### REMARKS/ARGUMENTS

### **AMENDMENT TO THE DRAWINGS**

FIGURE 2

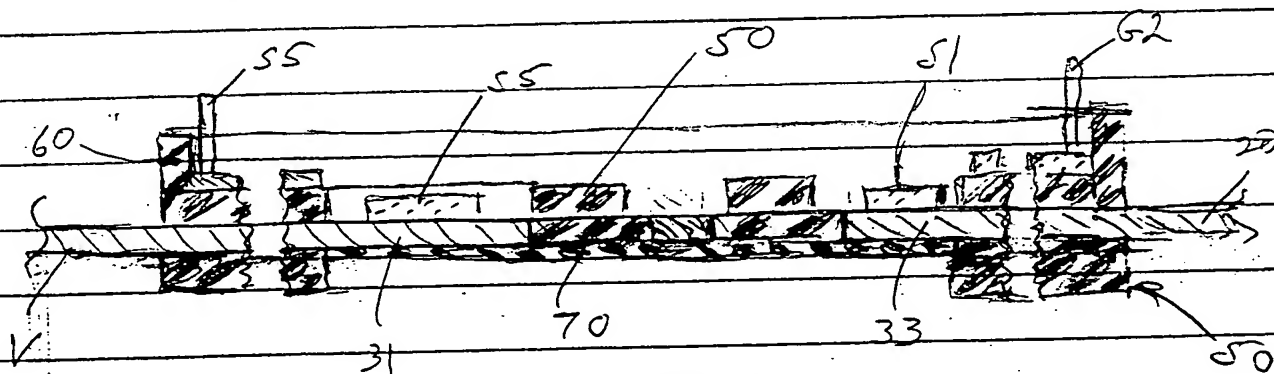
Submitted herewith is a replacement sheet containing corrected Figure 2. The corrected Figure 2 is now consistent with the original disclosure in Provisional Application No. 60/175,802 (copy enclosed). Furthermore, Figure 2 now properly illustrates the disclosed description in the application, parent application and the provisional application which calls for the lead frame to be insert molded within the insulation housing.

In addition, the specification has been amended to correct an obvious error with respect to the description of Figure 2, as well as other obvious errors.

Fig. 2 has been amended. The attached sheet of formal drawings replaces the original sheet including Figs. 1 and 2.
